SERVICE BULLETIN

No. 559

Piper Aircraft Corporation

Subject: Rudder Tail Light Inspection

SECTION A-A

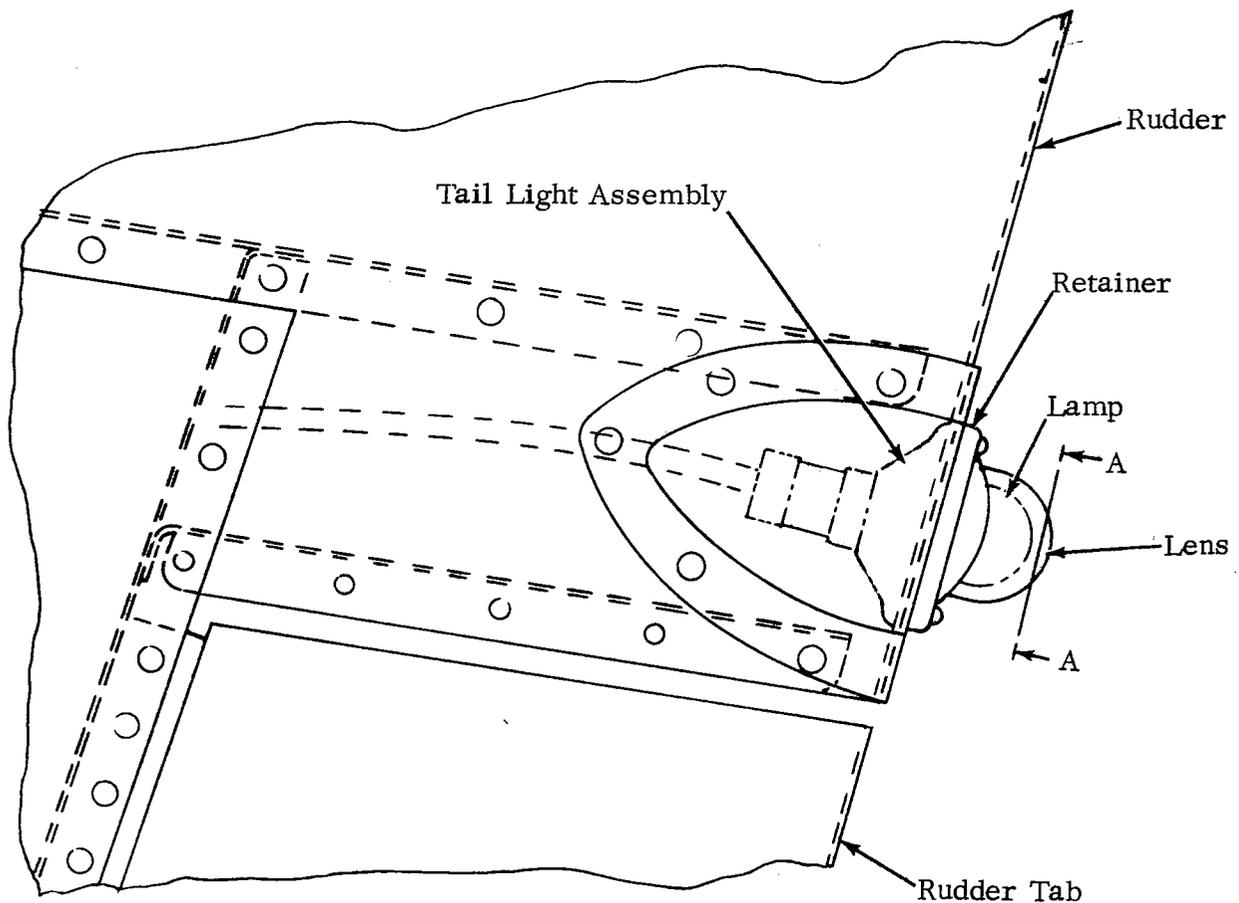
Purpose: It has been brought to our attention that the rudder mounted tail light assembly may be installed incorrectly on the above referenced group of aircraft; this condition causes an improper light arc, or "sweep" - as specified in the applicable FAR, due to the position of the lamp filaments with respect to the adjacent retainer shield (see attached sketch/instruction data for an illustration of this condition).

1. Remove tail light retainer and lens from rudder by removing the two screws.
2. Inspect lamp to determine if filaments are in a vertical or horizontal position and inspect retainer to determine if it is formed to shield both sides or top and bottom of lamp. Refer to Section A-A for views of correct and incorrect units.
 - a. If filaments are in a vertical position, and retainer is formed to shield both sides of lamp, correct tail light assembly is installed. Reinstall lens and retainer.
 - b. If filaments are in a horizontal position, and/or retainer is formed to shield top and bottom of lamp, incorrect tail light assembly is installed and must be replaced with a new assembly, Piper part no. 472 956.
3. Make proper logbook entry of Service Bulletin compliance.

Material Required: One each per aircraft Tail Light Assembly, Piper Part Number 472 956 - only if required per Instructions, (attached).
